U.S. Forest Service – Monongahela and George Washington National Forests

Date/Time: Monday, November 21, 2016 @ 10:30am-12:30pm (Eastern)

Background

The primary purpose of the meeting was for Atlantic Coast Pipeline (ACP) to present and solicit Forest Service feedback on ACP's proposed *Best in Class (BIC) Steep Slopes Program as well as demonstrating how this would be applied to steep slopes in the National Forests*. The accompanying presentation and materials were distributed to Forest Service staff prior to or during the meeting. The notes summarize discussion and content not reflected in the accompanying materials.

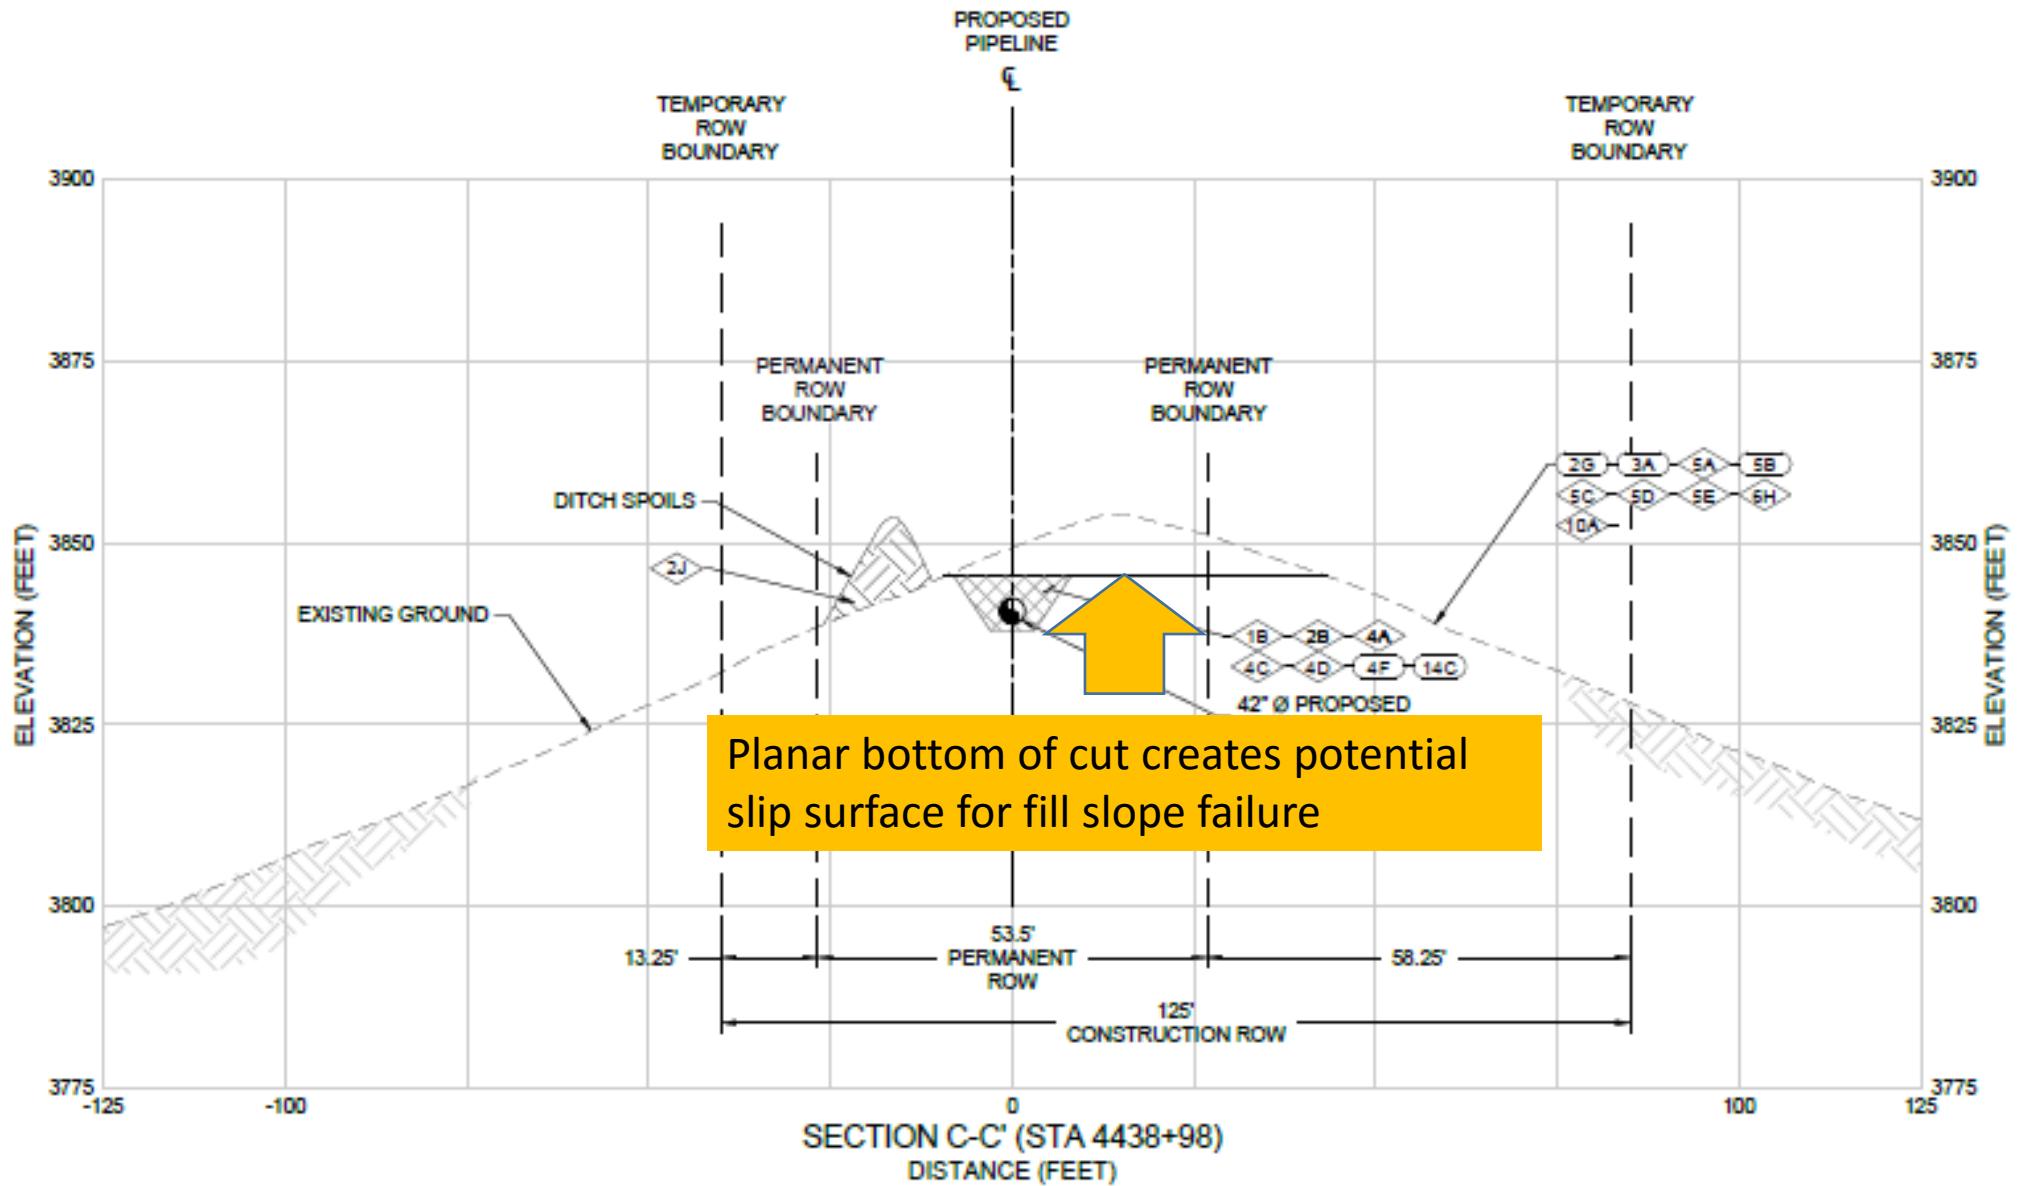
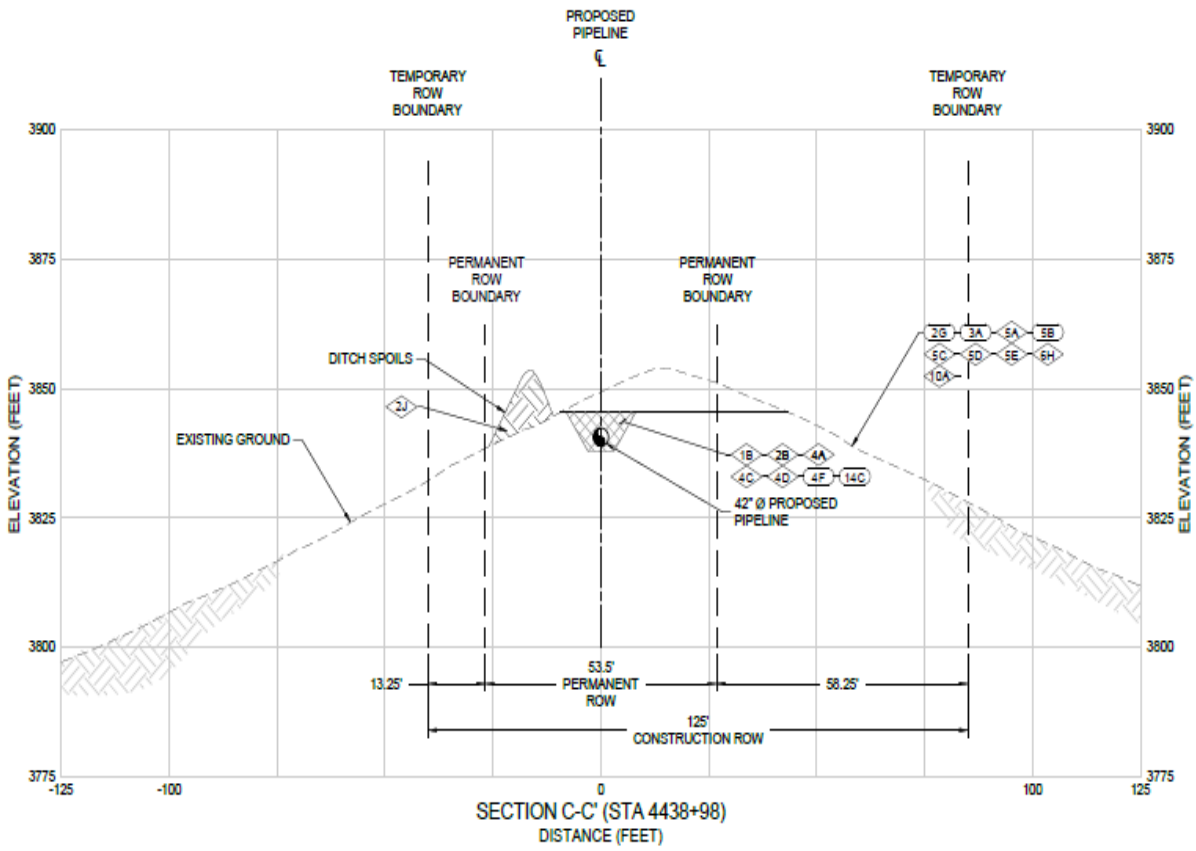
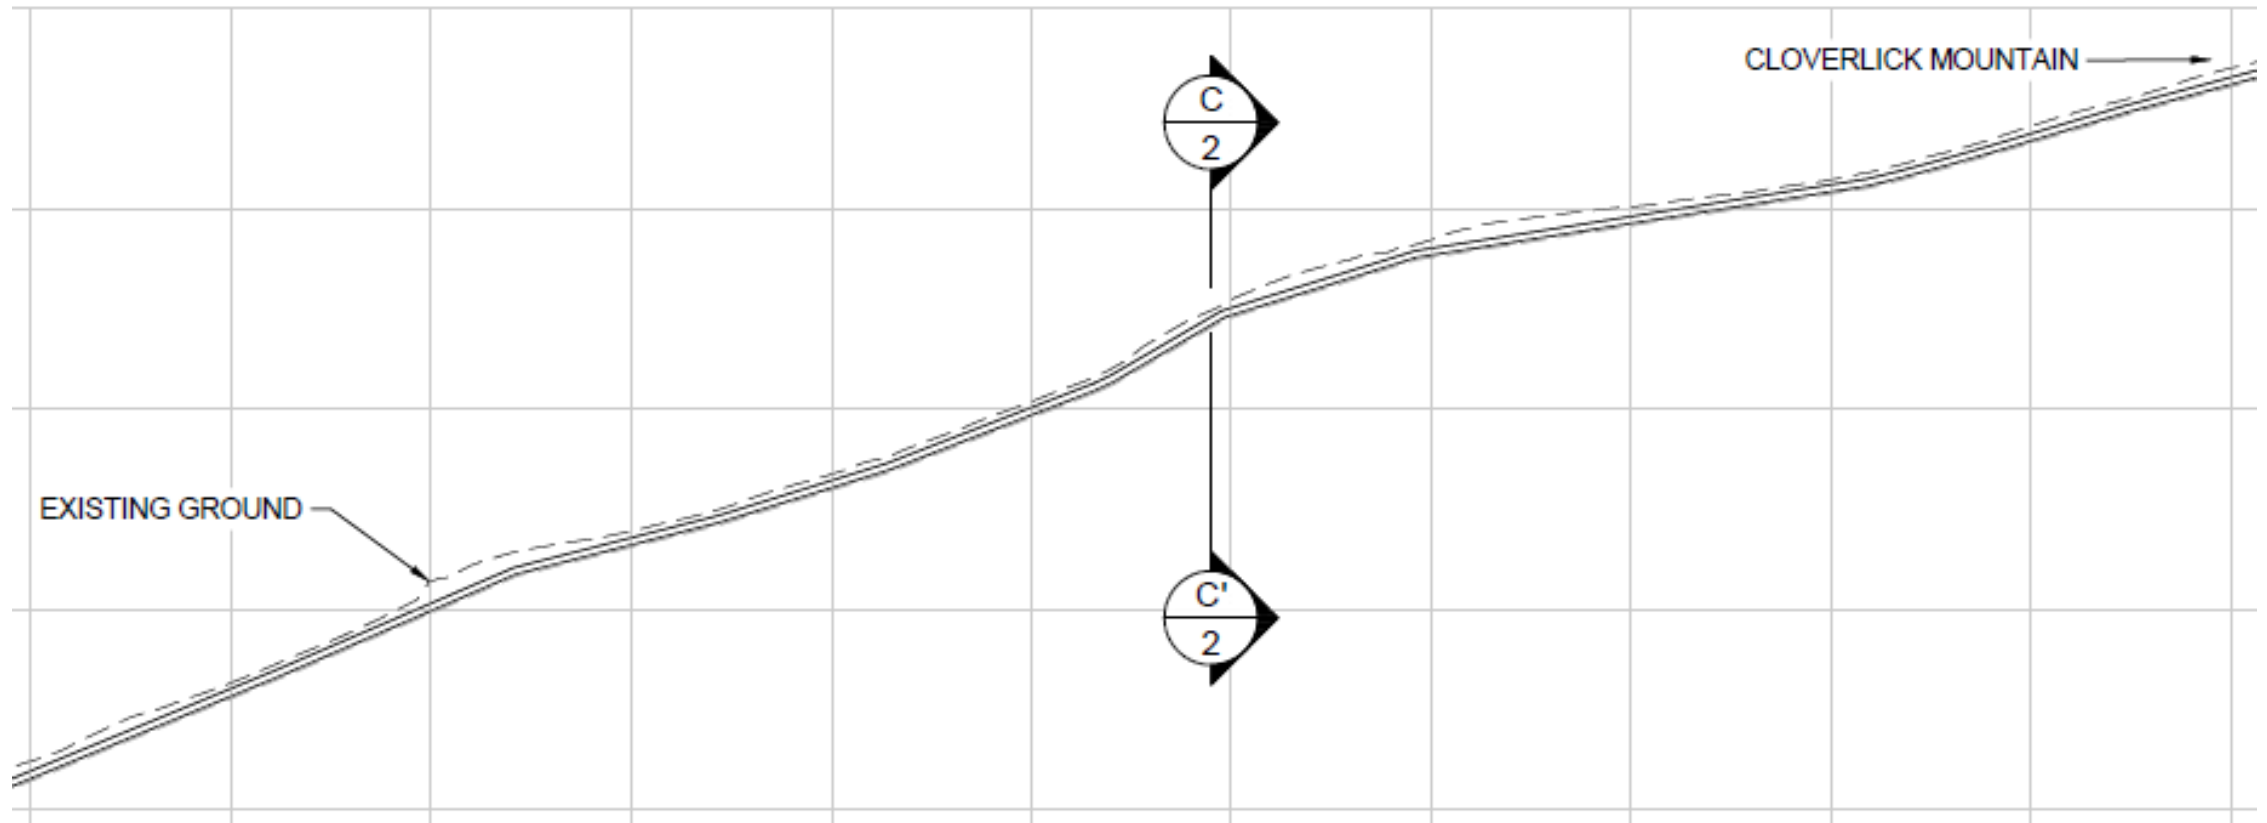
Tom C said the Forest Service (FS) want to see accounting for mass balance and how materials will be moved on the site. He added the FS wants to see designs similar to the one on the right, but to scale so it shows the amount of spoil.

Tom C. said this 52' wide cut creates a surface for slippage.

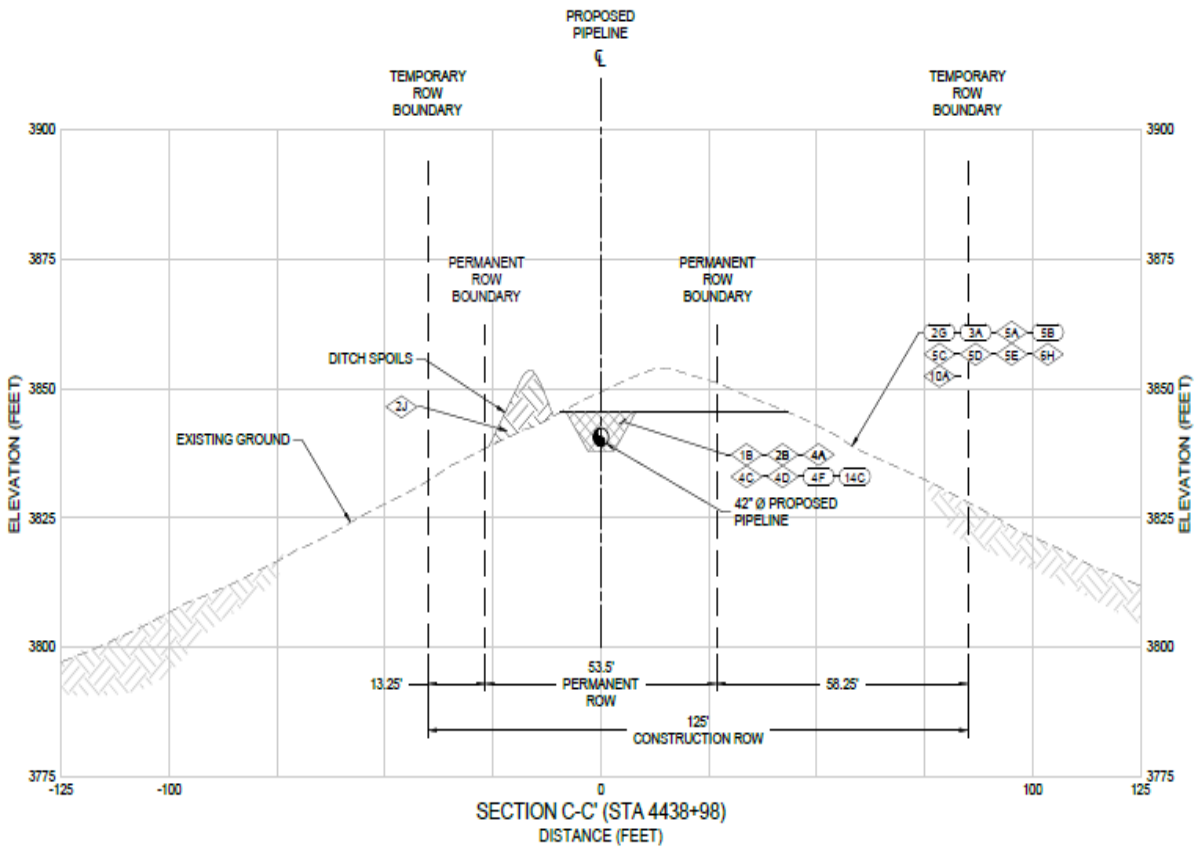
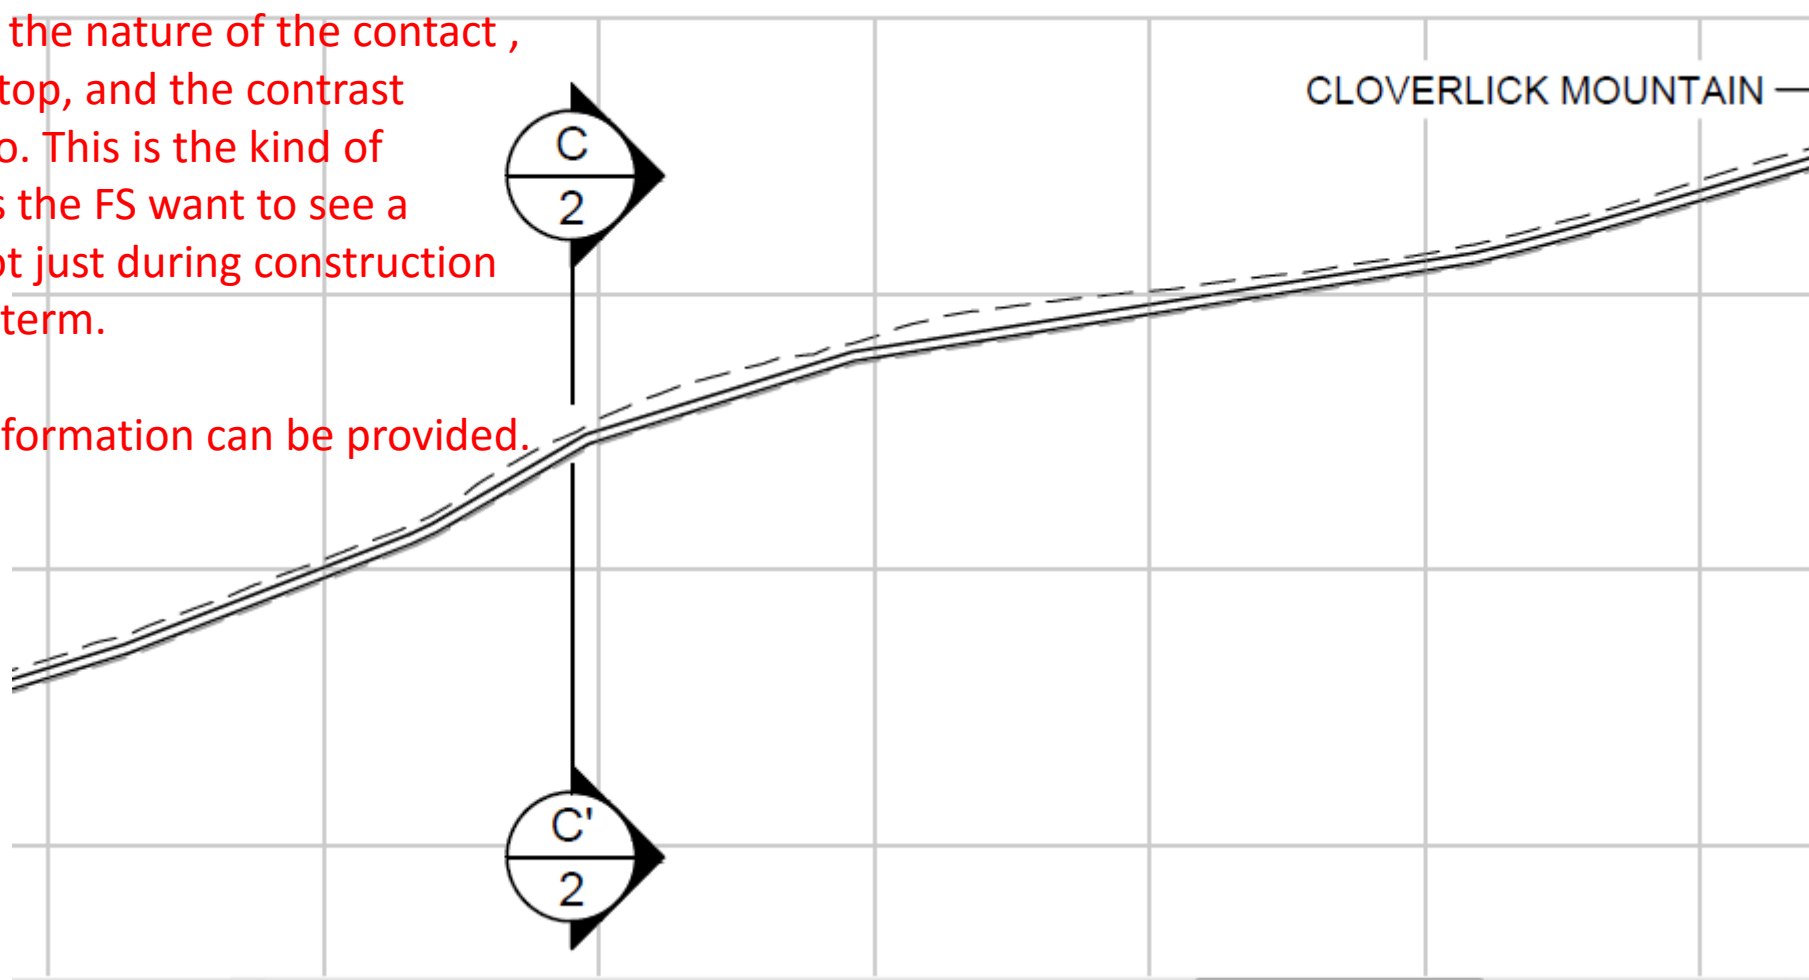
Tom C. said this is the profile, planar surface roughly parallel to the existing slope, in order to look at that the FS will need a plan in detail.

Tom C. said the project is doing 2 things, creating a planar slip surface and then piling loose aggregate on top of that. FS needs to look at the nature of the contact, the material on top, and the contrast between the two. This is the kind of detailed analysis the FS want to see a narrative on; not just during construction but for the long term.

Colin said this information can be provided.

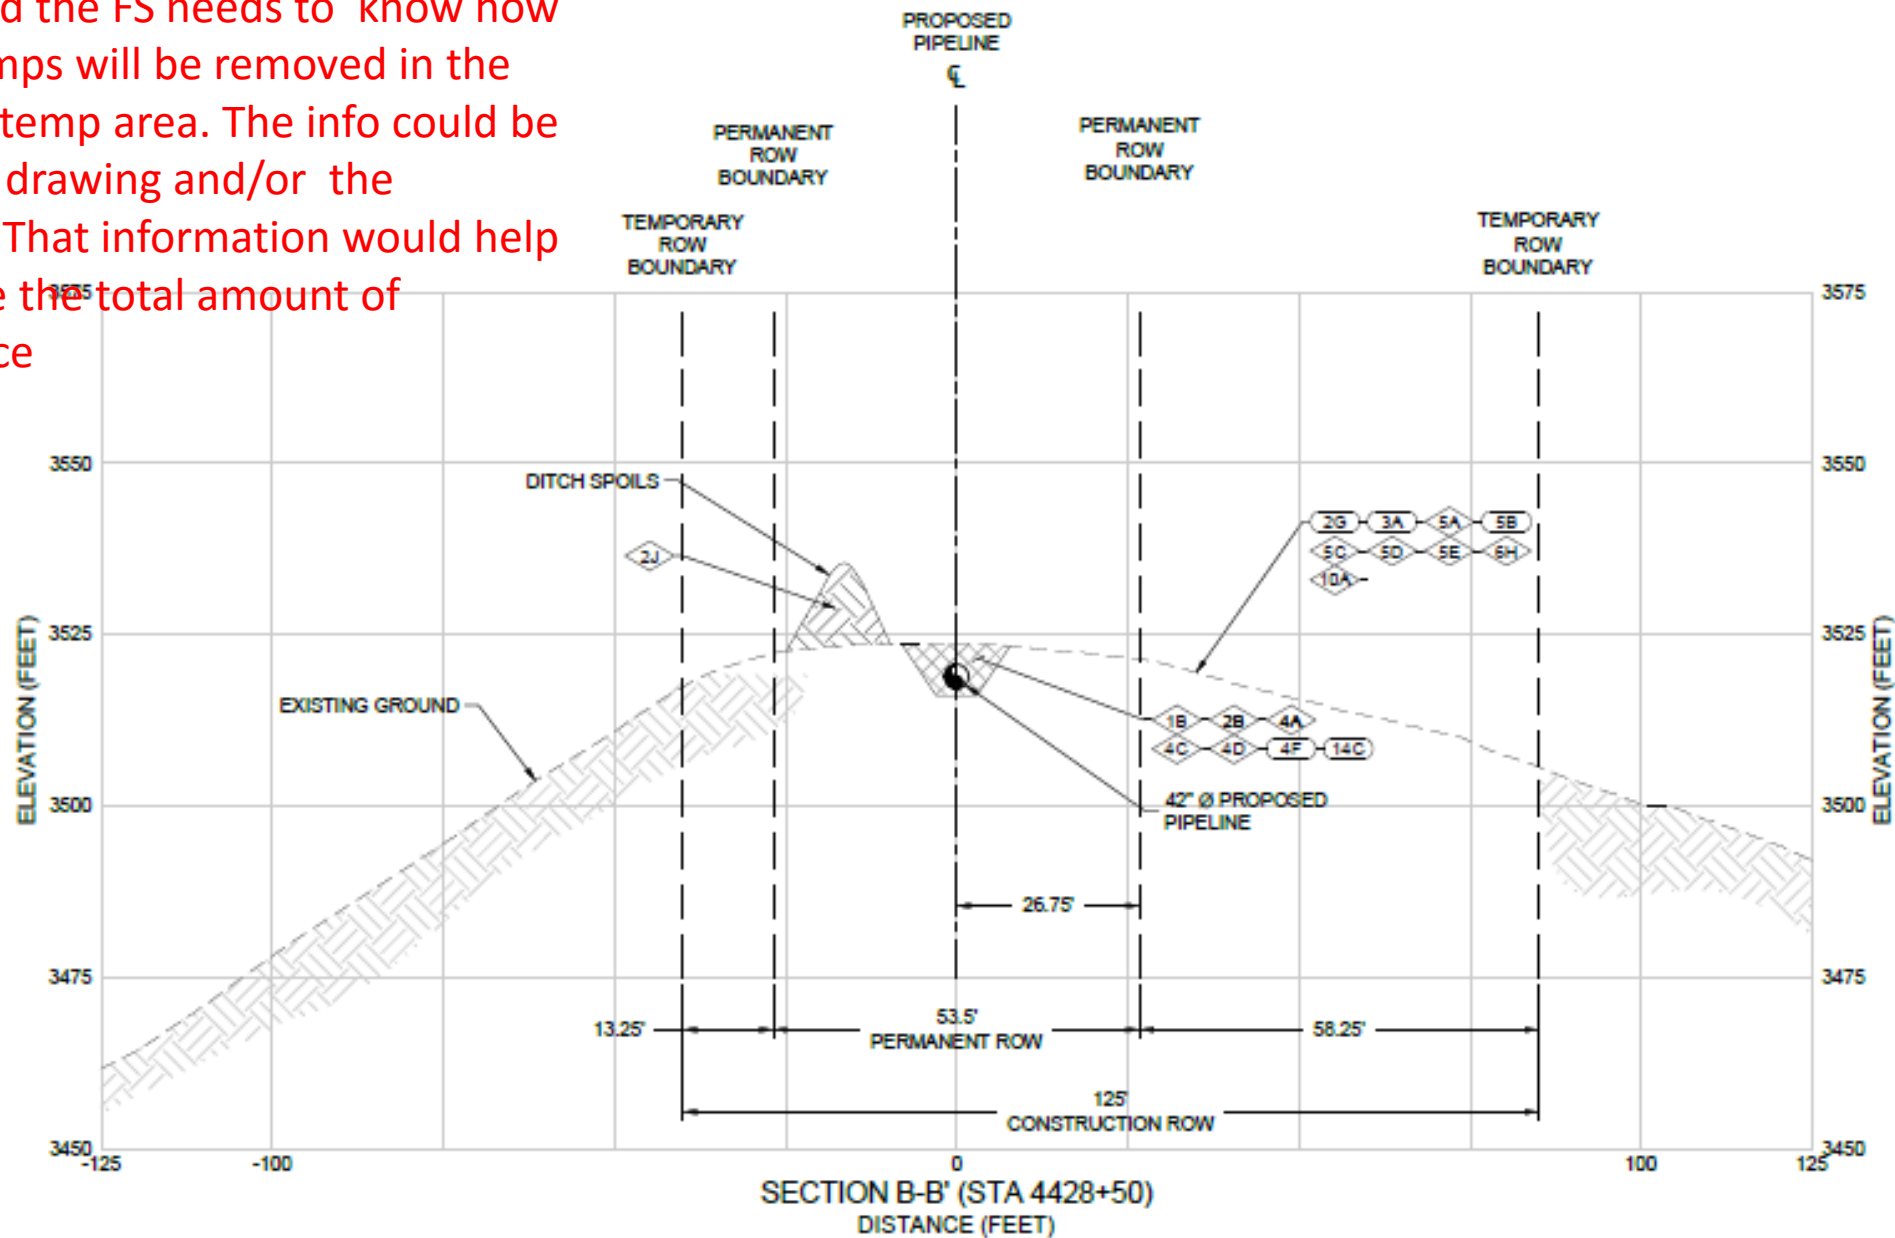
Tom C. said the FS needs to know how many stumps will be removed in the ROW and temp area. The info could be put in the drawing and/or the narrative. That information would help determine the total amount of disturbance
